TAB Punchlist

L05629_Langhorne (PA) FSU

1440 Lincoln Highway, Langhorne, Pennsylvania

#29 [EXHA 999] [NEW] (MISC) Grease cleanout

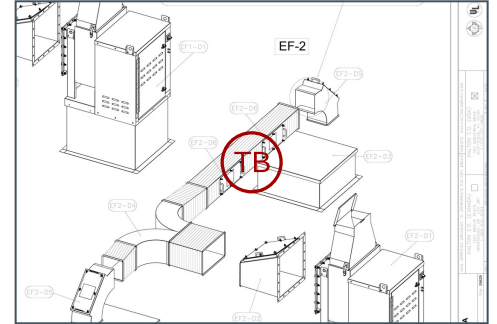
EF-2 needs another Greas cleanout installed on the Runout for HD-2. Specd is two cleanout in the run only one is cut-in and installed.

#28 [HOOD 508] [NEW] Sidejet arm angle bracket.

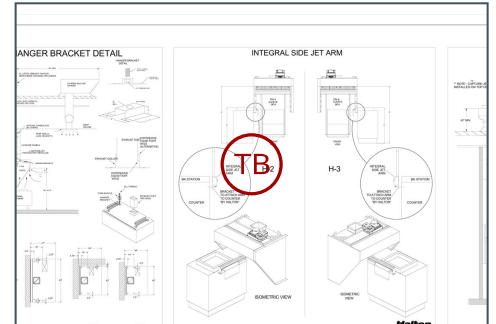
(HD-2)The Halton supplied angle bracket that connects the integral sidejet arm to the counter is missing or not installed correctly. Secure bracket to arm and bracket to counter underneath removeable fry dump via stainless steel rivets.

#26 [UNIT 504] [NEW] Equipment Fresh Air Tempering.

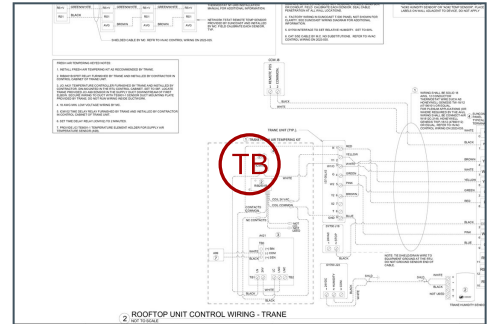
104 Timers are not functioning correctly. It was observed Heating turns on immediately after cooling stops and runs for approximately 1 min before turning off

#24 [UNIT 517] [NEW] Condensate piping construction.

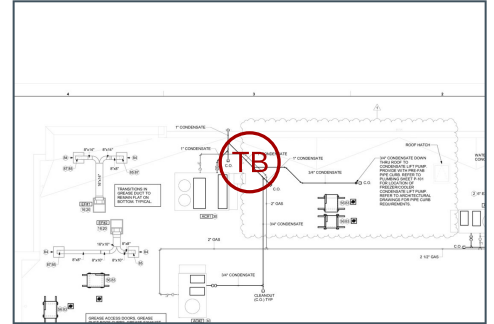
Equipment condensate piping Roof routing does not match prints.

#23 [UNIT 523] [NEW] Trane powered exhaust.

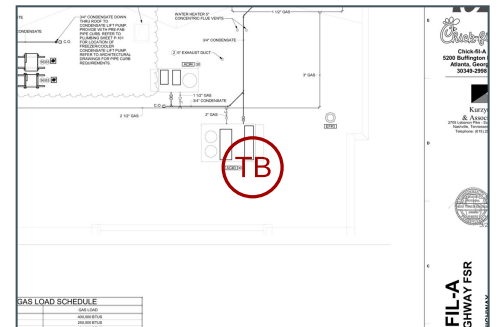
AC-3 Powered Exhaust fan wheel does not spin freely and rubs.

Item Reopened, Powered exhaust fan is rubbing again\

MC has adjusted the fan wheel and now spins freely.

#18 [REFG 999] [NEW] (MISC) WIF Thermometer

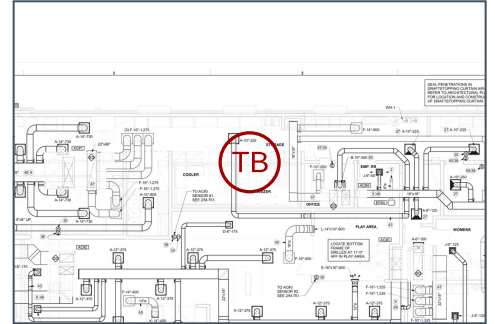
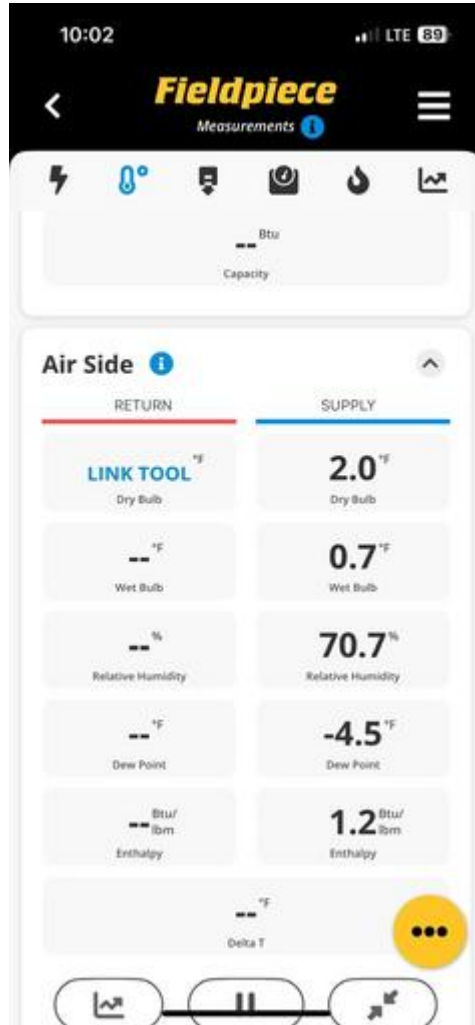
WIF Thermometer is not reading true to the Freezer Temp, Inside was 2F and thermometer is reading -15F
